Friday, April 19, 2024

DF2024-016 – Siegel and Shuster Tribute Plaza (Artwork Only): Seeking Final Approval

Location: 300 Lakeside Avenue East

Cleveland City Planning Commission

CONCEPTUAL SITE PLAN

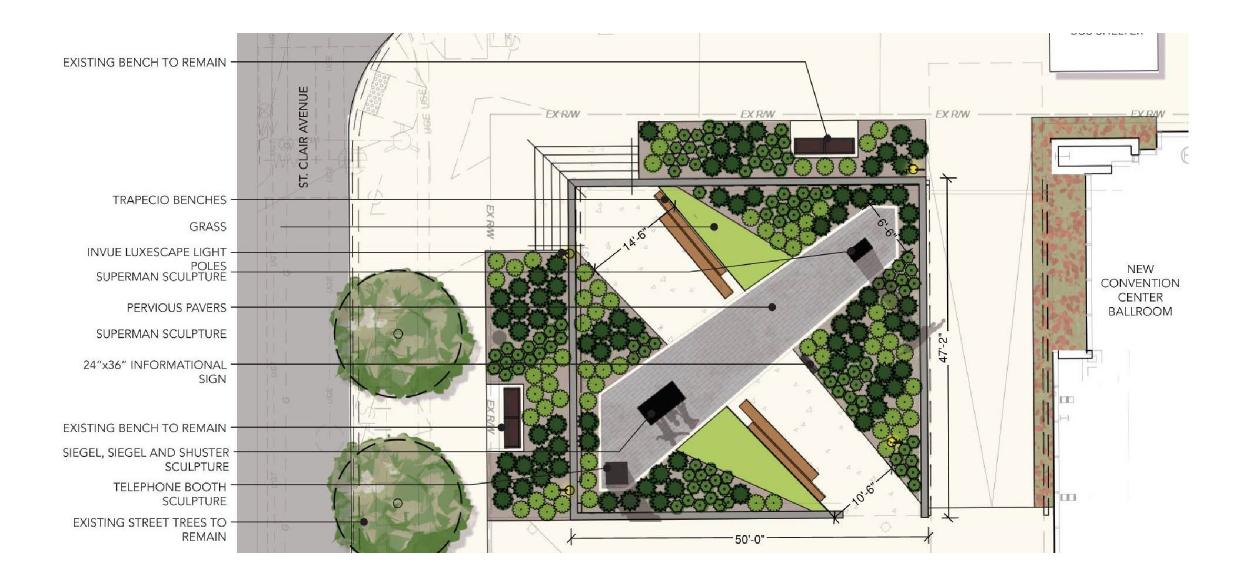
Revised concrete area around benches be reflected on plans for admin approval.

Grass triangle areas be enhanced for additional open area and to avoid trampling of landscaping. Include map/address of other relevant Superman sites on the plaque, including the Glenville childhood home(s) of Siegel and Shuster.

Consider back-to-back benches.

SITE CONTEXT Site Plan | Pedestrian Ingress & Egress

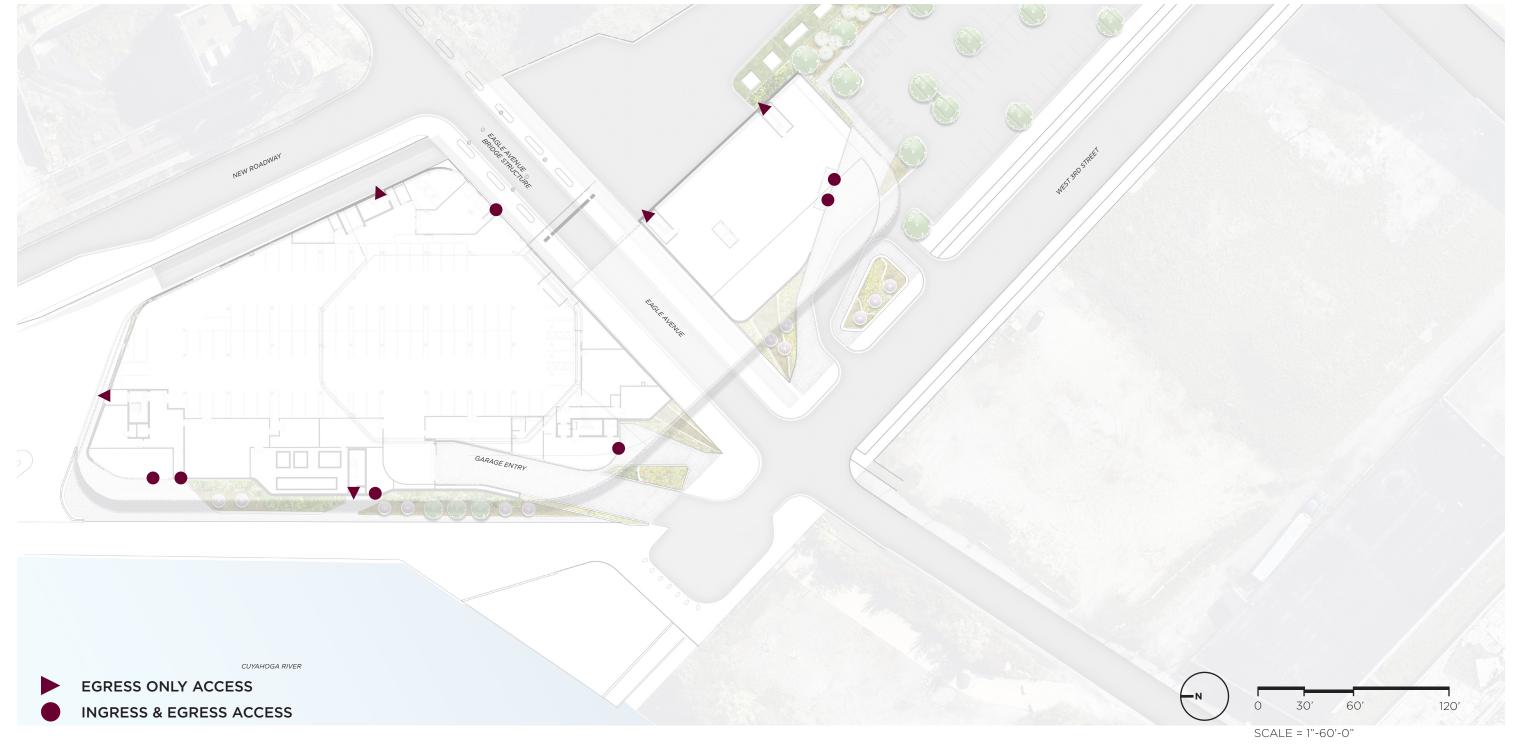
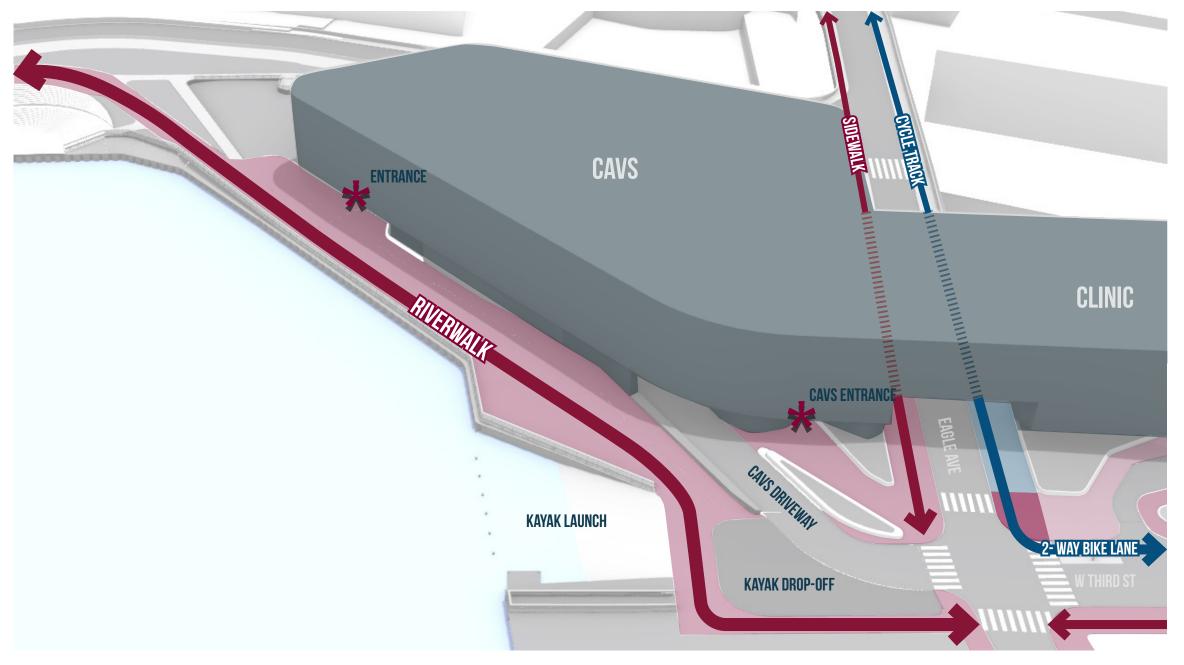
- Per development agreement process, all smaller area plans are to be reviewed by the Commission.
- Southeastern end of the riverwalk at W. 3rd Street to be better integrated into the overall site context and future trail expansion opportunities. Currently the riverwalk plan dead-ends at the player parking entrance, creating conflicts with riverwalk users & boat launch. Relocate or reconsider player parking entrance design and enhance this key connection point.

- Articulate and show boat launch circulation and usage, including drop-off & pick-up with a trailer, and how that interconnects to streetscape.
- Further articulation needed for vehicular circulation, including connections to Eagle Ave and Canal Road, and adjacent properties/rights-of-way.
